# WILLIAMSON COUNTY, TEXAS CHANGE ORDER NUMBER: 11

# Seward Junction Improvements Williamson County Project No. 1812-282

# Change Order No. 11

# Change Order No. 10

SCALE	AS NOTED
DATE	1/12/2021
SHEET NUMBER	15 of 92

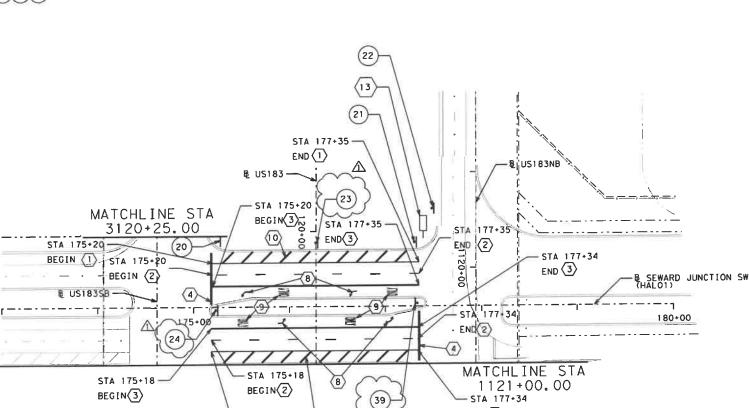
All W4-4P signs need to be 36"x18"

SMALL SIGN DETAILS

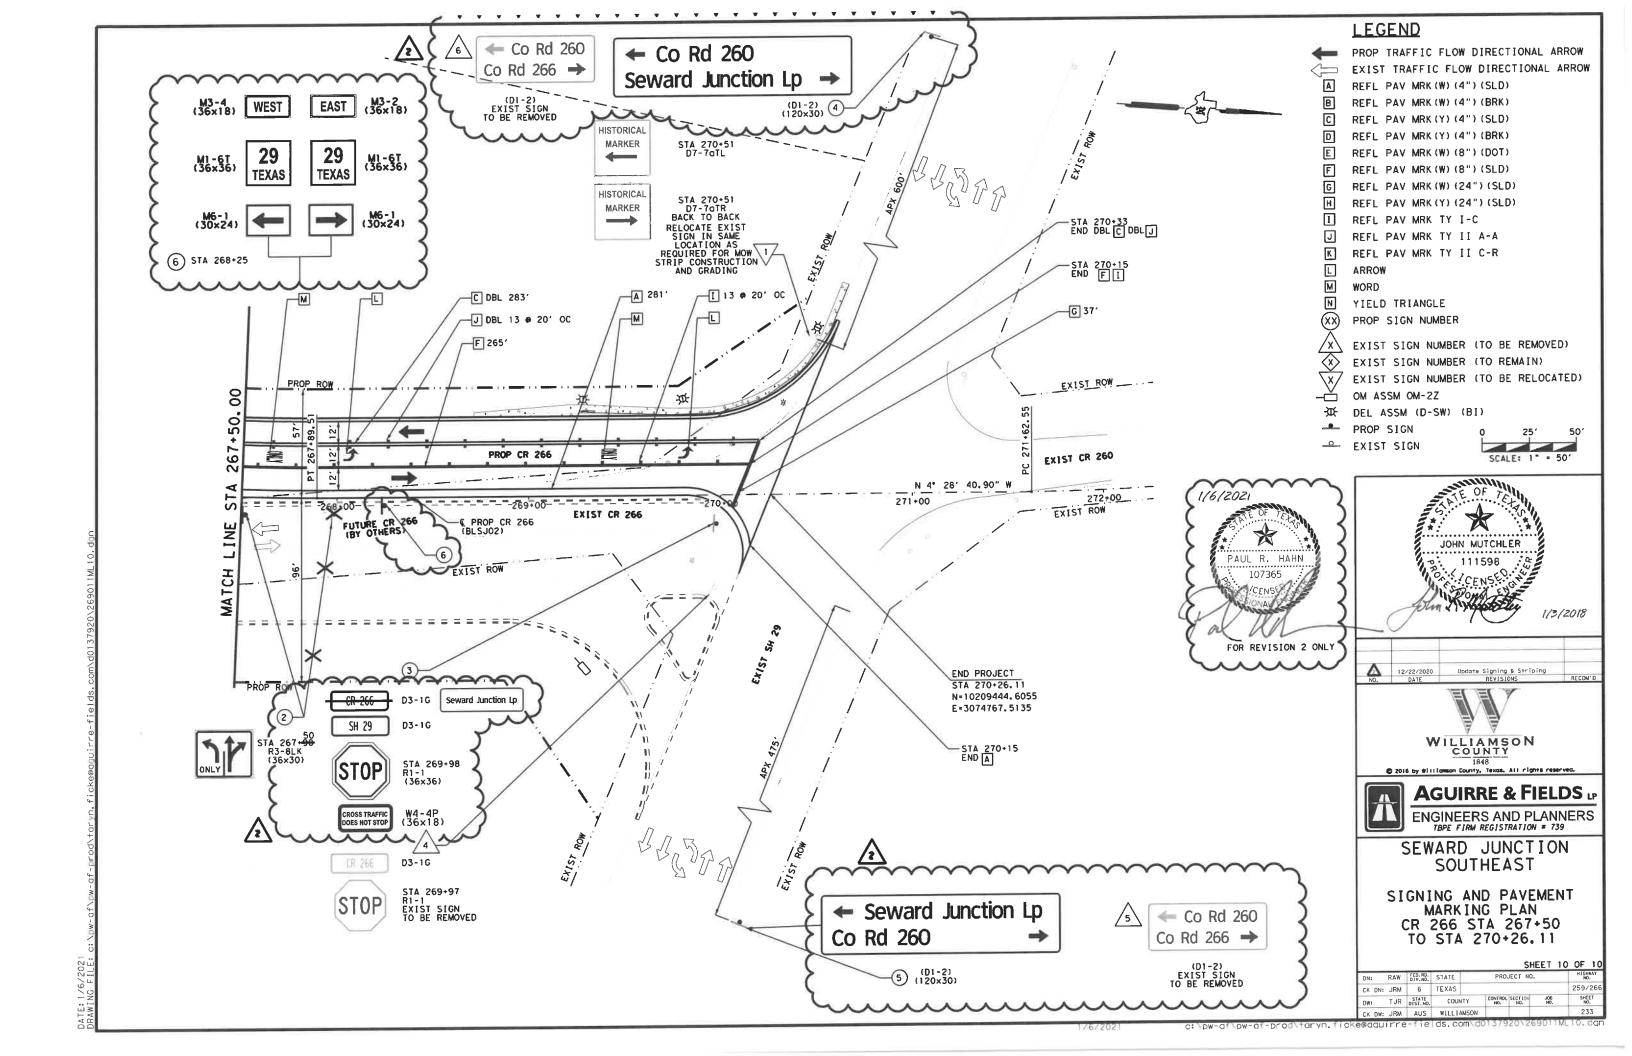
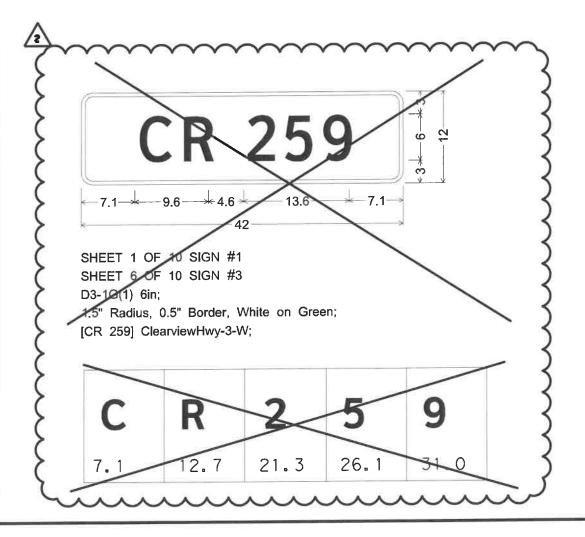
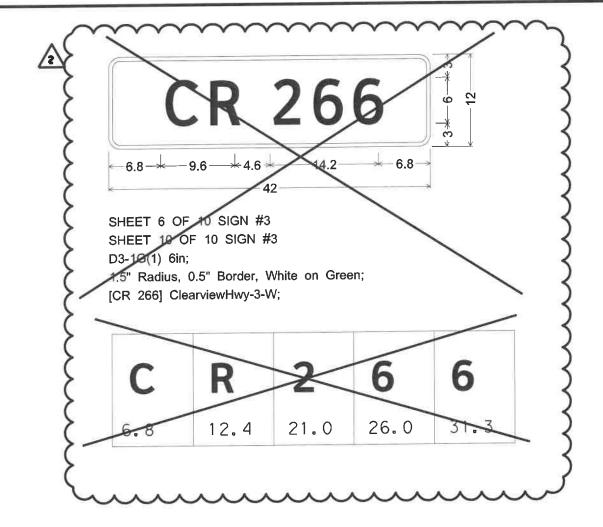
12/22/2070 NEW SHEET - ADDED SIGNS
DATE REVISIONS RECOM\*

SMALL SIGN DETAILS

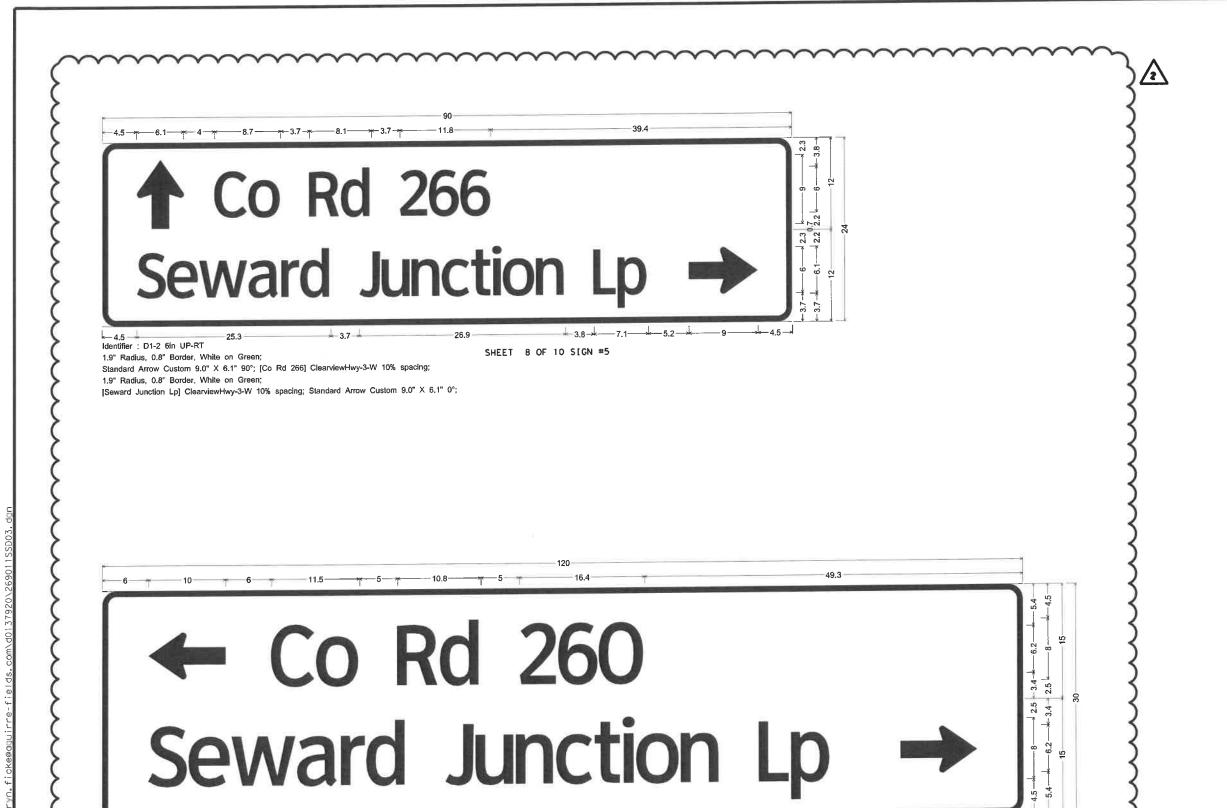
12/22/2020 NEW SHEET - ADDED SIGNS
DATE REVISIONS

SEWARD JUNCTION SOUTHEAST

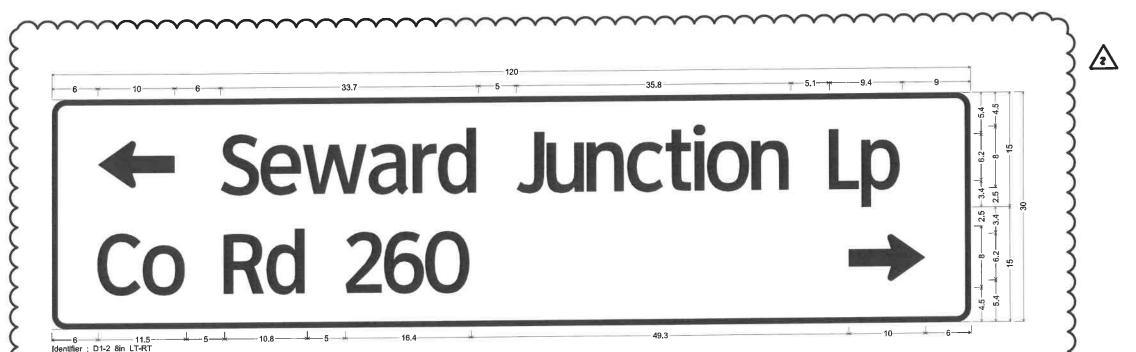
12/22/2020 NEW SHEET - ADDED SIGNS
DATE REVISIONS RECOM'D
